Project 86-060-24
December 1990

Response to Comments and Proposed Reclamation Plan Modifications

Church Rock Site
Gallup, New Mexico

United Nuclear Corporation
Gallup, New Mexico

DRAWING NUMBER 86-060-A426

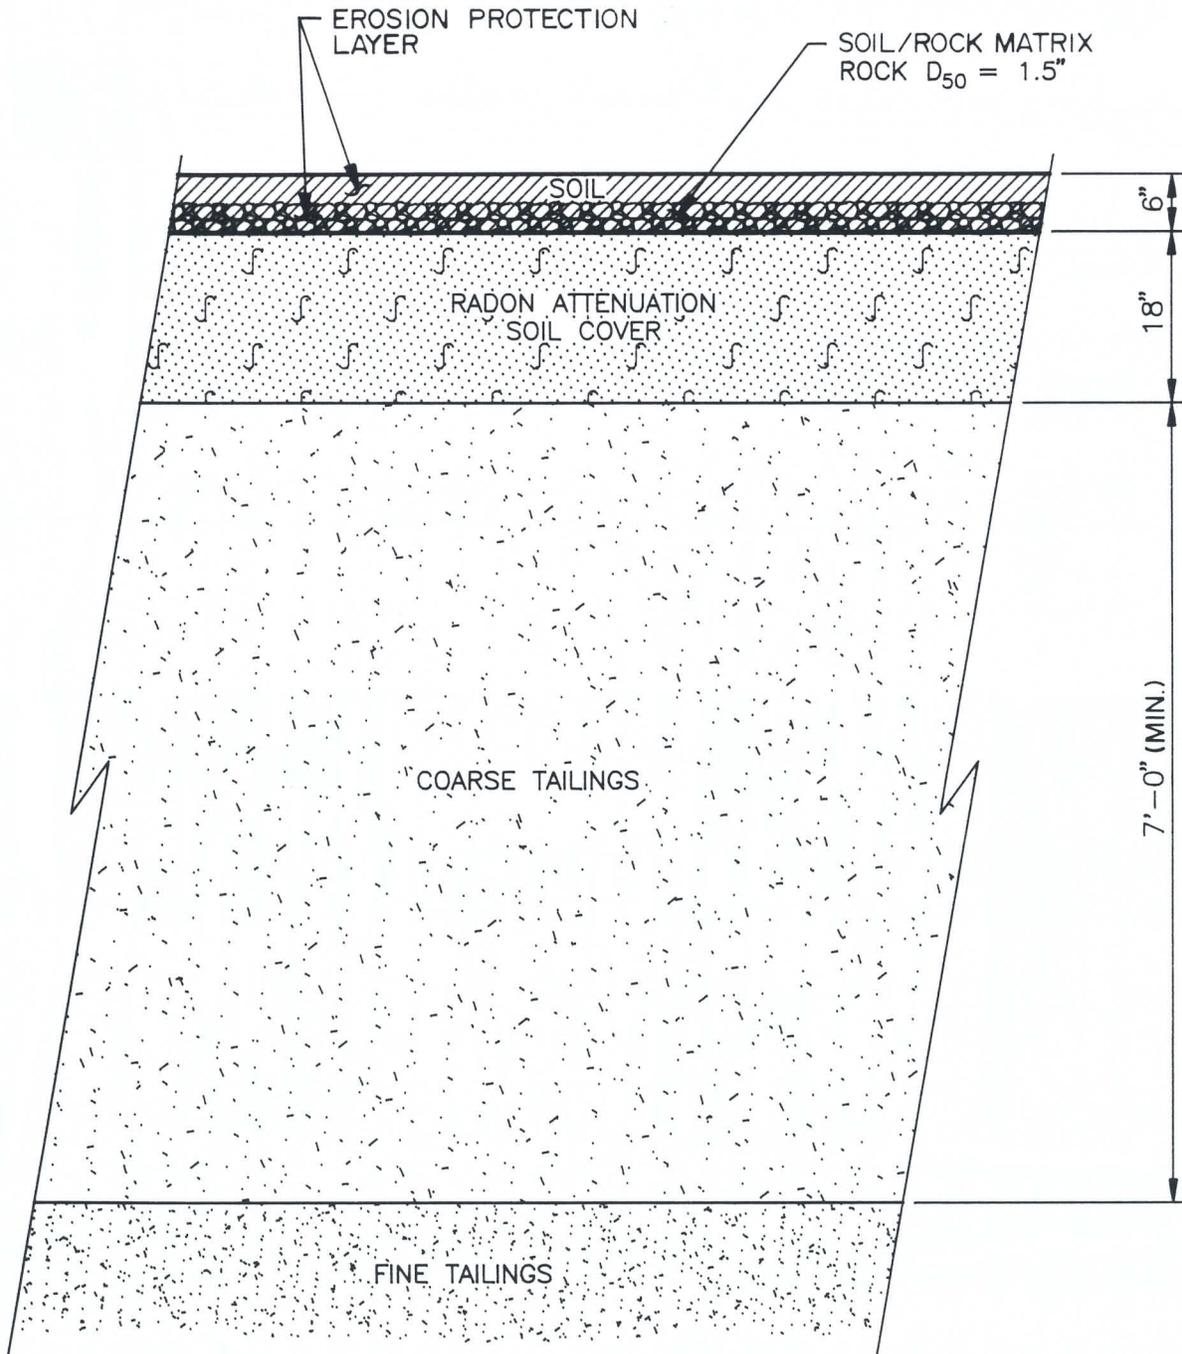
The proposed soil/rock matrix will be installed over a 1.5 foot radon attenuation soil cover designed to control radon emanation to below 20 picoCuries per meter squared per second ($\text{pCi}/\text{m}^2/\text{sec}$). This represents a reduction in radon soil cover requirement of 1.9 feet from the original design requirement of 3.4 feet. As described in greater detail herein, the reduction is justified by the use of data collected during the first two years of construction of the first foot of soil cover. Extensive testing demonstrates that the soil characteristics of the material used for construction is such that the reduction in radon attenuation soil cover is warranted. The resulting total thickness of the soil cover over the tailings including the soil/rock matrix is 2.0 feet.

The radon attenuation soil cover portion of the tailings soil cover has been reduced to a total thickness of 1.5 feet to be constructed over regraded tailings. This would be then overlain by the 6-inch-thick soil/rock matrix. This layer would aid in further reducing radon emanation but has not been included in the analyses. Figure 2-1 illustrates the soil cover profile. Based on recent results obtained from the RADON computer model, the reduced radon attenuation soil cover of 1.5 feet will limit radon emissions from the reclaimed tailings impoundment to the required 20 pCi/m²/sec. A detailed discussion follows.

DATE: 11-12-90
 SCALE: AS SHOWN
 FIGURE 2-2
 DRAWING NUMBER 86-060-E425

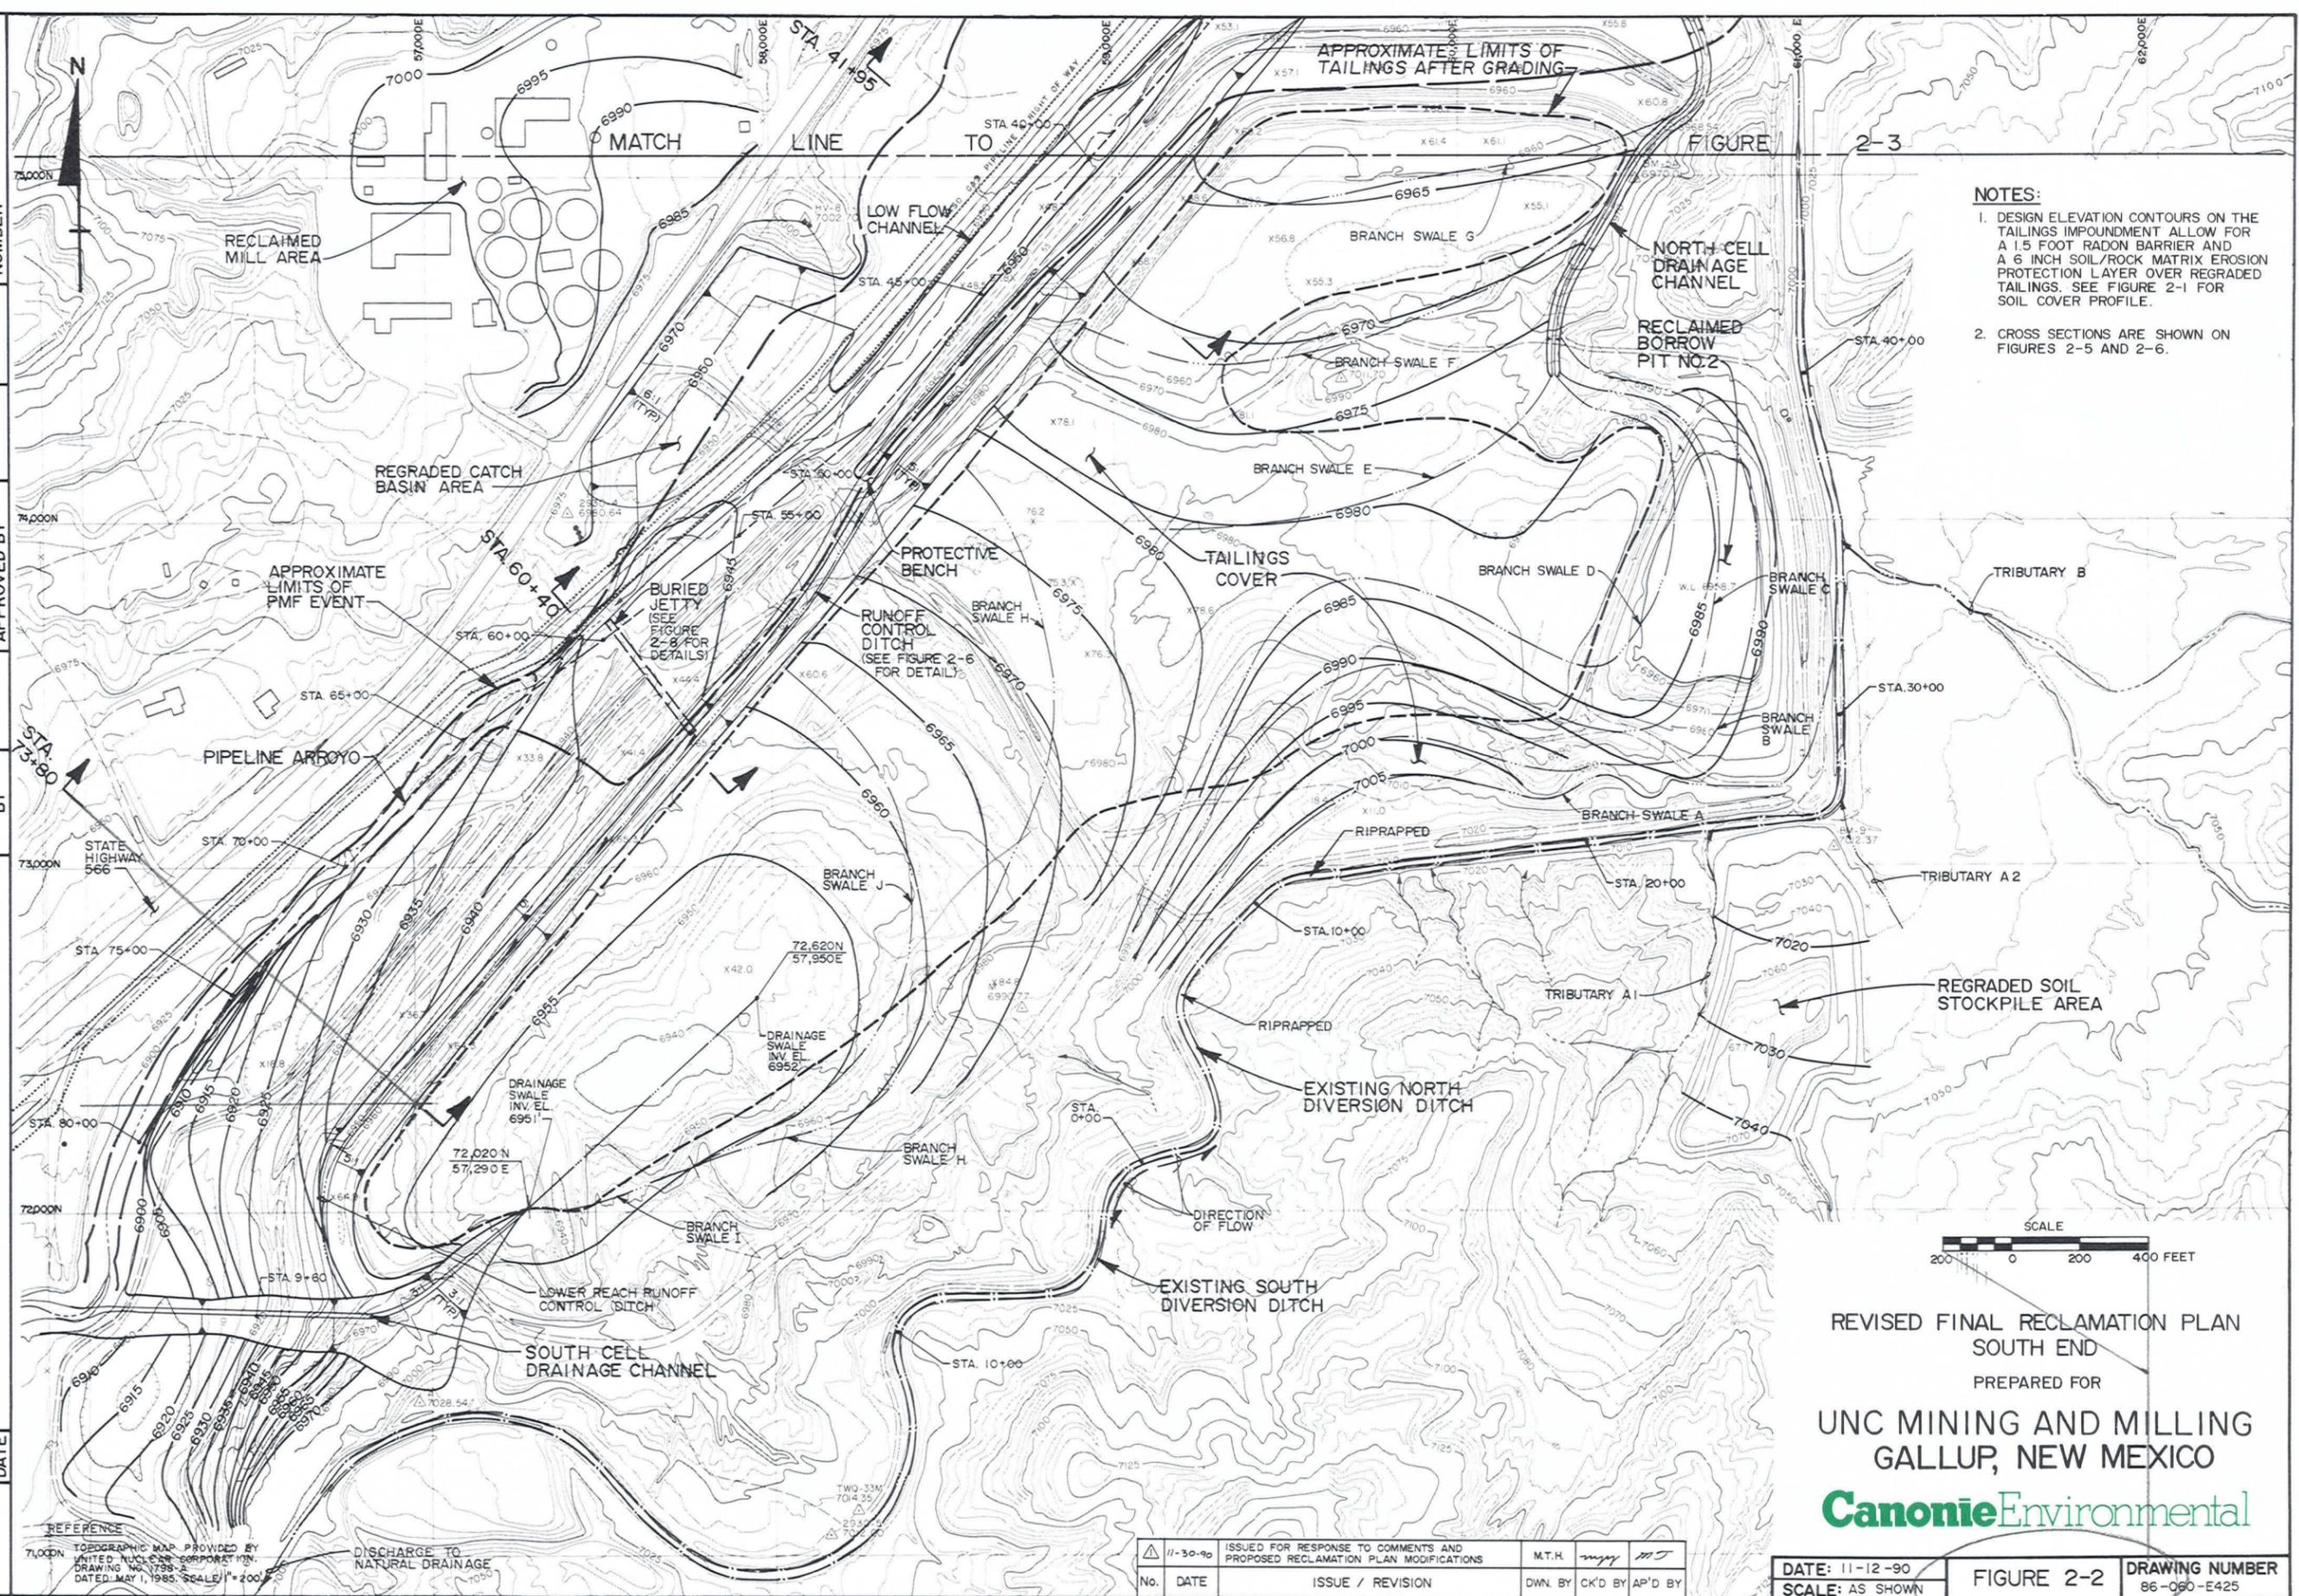
Figures 2-2 and 2-3 depict the proposed modified tailings impoundment configuration and grades at final reclamation. This configuration has been changed from that of the original reclamation plan (see Figure 1 of the August 31, 1988 responses to comments and Figure 3 of the September 12, 1990 response to comments) in three aspects. First, the surface contour elevations have been reduced 2 feet to reflect the resulting reduced tailings cover thickness. Second, additional swales have been added to the South Cell to collect surface water runoff. Third, the tailing's 2-foot soil cover will incorporate a 6-inch-thick soil/rock matrix to protect the cover from erosion. These proposed design modifications promote surface water drainage while maintaining the erosional stability of the tailings soil cover.

A modified design is proposed for the tailings embankment slopes that incorporates rock mulch armor for erosion protection of the upper portion of the embankment and the construction of a protective bench at the toe of the tailings embankment to provide a buffer between probable maximum flood (PMF) flows in Pipeline Arroyo and the toe of the tailings embankment. Figures 2-2 and 2-3 show the configuration of the proposed tailings

Figures 2-2 and 2-3 provide a plan view of the revised Pipeline Arroyo channel configuration at final reclamation. The channel will be modified only slightly from its present configuration to enhance its flow capacity

Figure 2-2 shows the location of the proposed jetty, while Figure 2-8 provides the jetty details. The jetty would be keyed into the nickpoint at its furthest extent to maximize the flow capacity within the nickpoint. The exact configuration of the eastern edge of the nickpoint will be determined in the field at the time of construction. For the present design, the low-flow channel was considered to be 30 feet wide and located at the west terminus of the jetty. The low-flow channel may be wider, depending on the nickpoint configuration.

Three critical locations are shown on Figure 2-2. These three confluences (A1, A2, and B) involve tributaries to the North Diversion Ditch that provide a large proportion of the total flow of the diversion ditches at discrete locations. None of the tributaries to the South Diversion Ditch provide a large proportion of flow to the ditch.

DATE: 11-9-90	FIGURE 2-4	DRAWING NUMBER 86-060-B420
SCALE: AS SHOWN

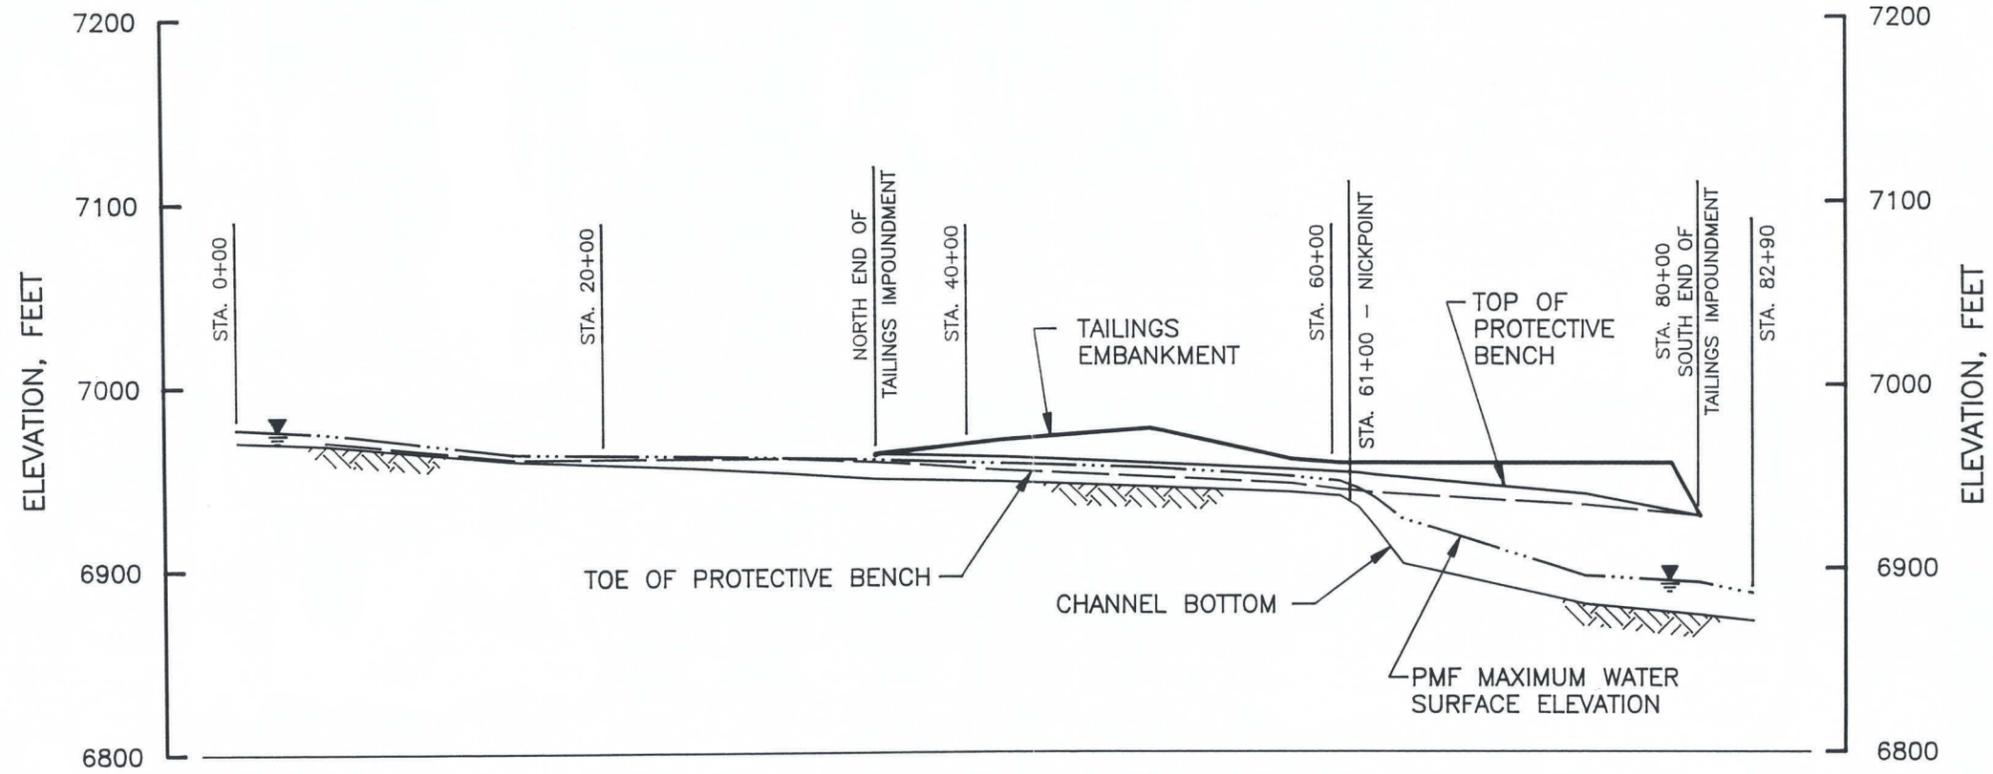
Figure 2-4 shows that the PMF water surface elevation is less than that of the top of the proposed protective bench. Thus, the bench would protect the embankment toe and would keep the runoff control ditch above the PMF level. The average velocities and depths of the PMF within Pipeline Arroyo along the 5H:1V sideslopes of the protective bench were determined by the HEC-2 program and are summarized below:

Figure 2-4 provides profiles of the channel bottom, PMF water surface elevation (WSEL), protective bench toe, protective bench top, and tailings embankment top from station 0+00 to station 82+90. The profile shows the shallow slopes of the Pipeline Arroyo channel bottom upstream from the nickpoint and the spatial relationship of these features.

DATE: 11-12-90	FIGURE 2-5	DRAWING NUMBER 86-060-B424
SCALE: AS SHOWN

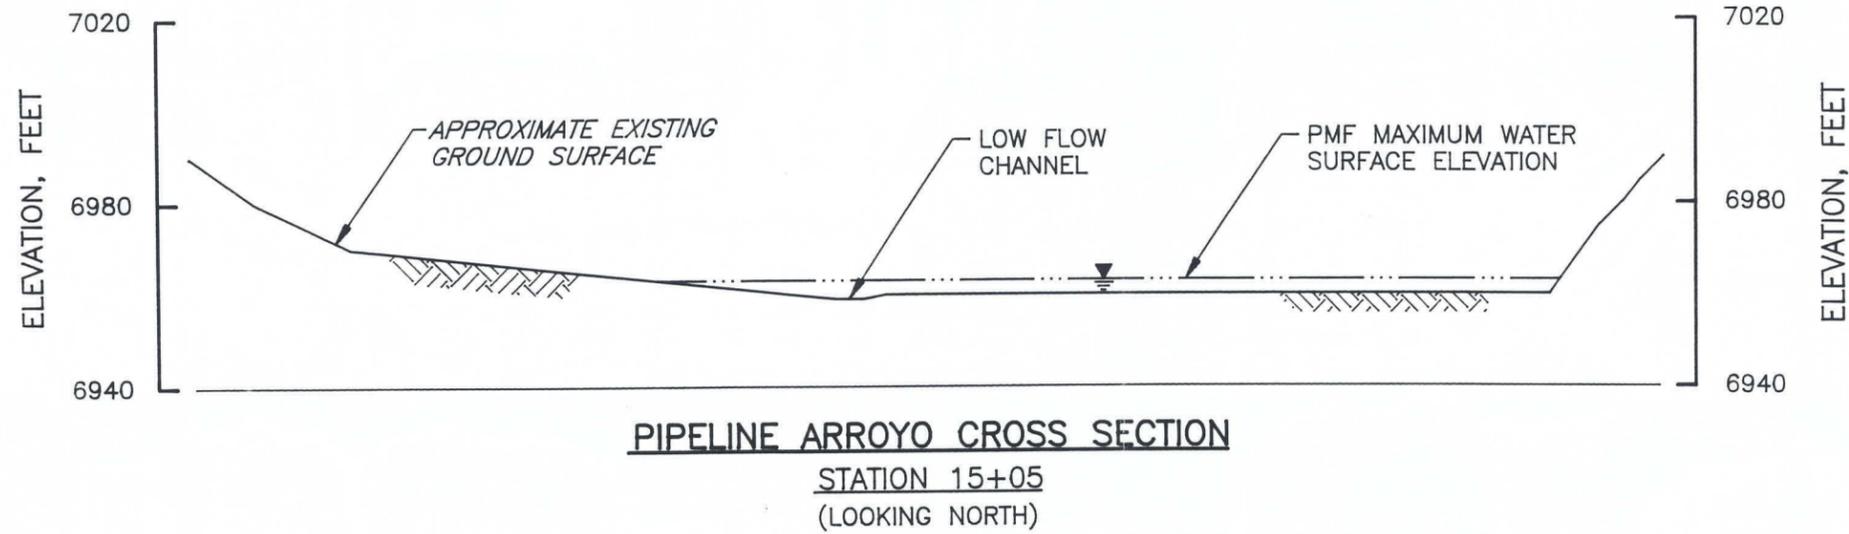
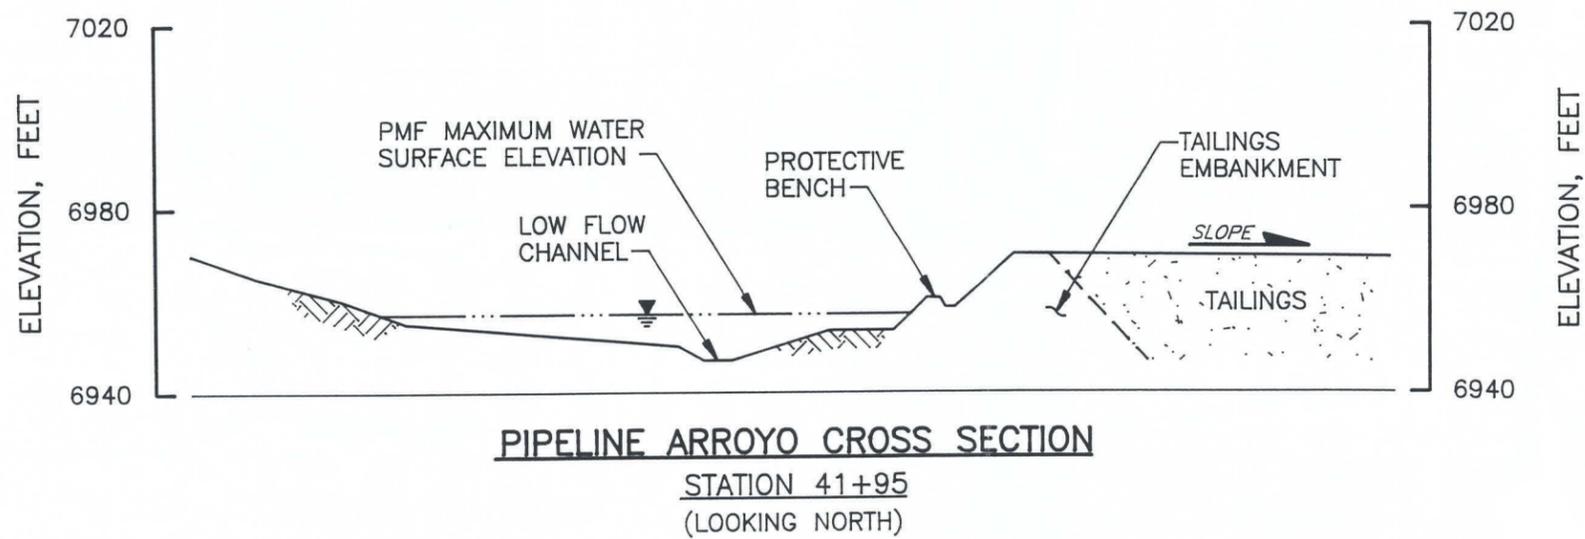
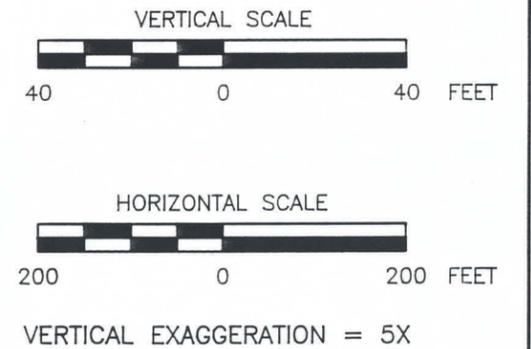
Figures 2-5 and 2-6 provide several cross sections across Pipeline Arroyo to the reclaimed tailings embankment top. These cross sections also illustrate the spatial relationships between the channel, bench, and embankment.
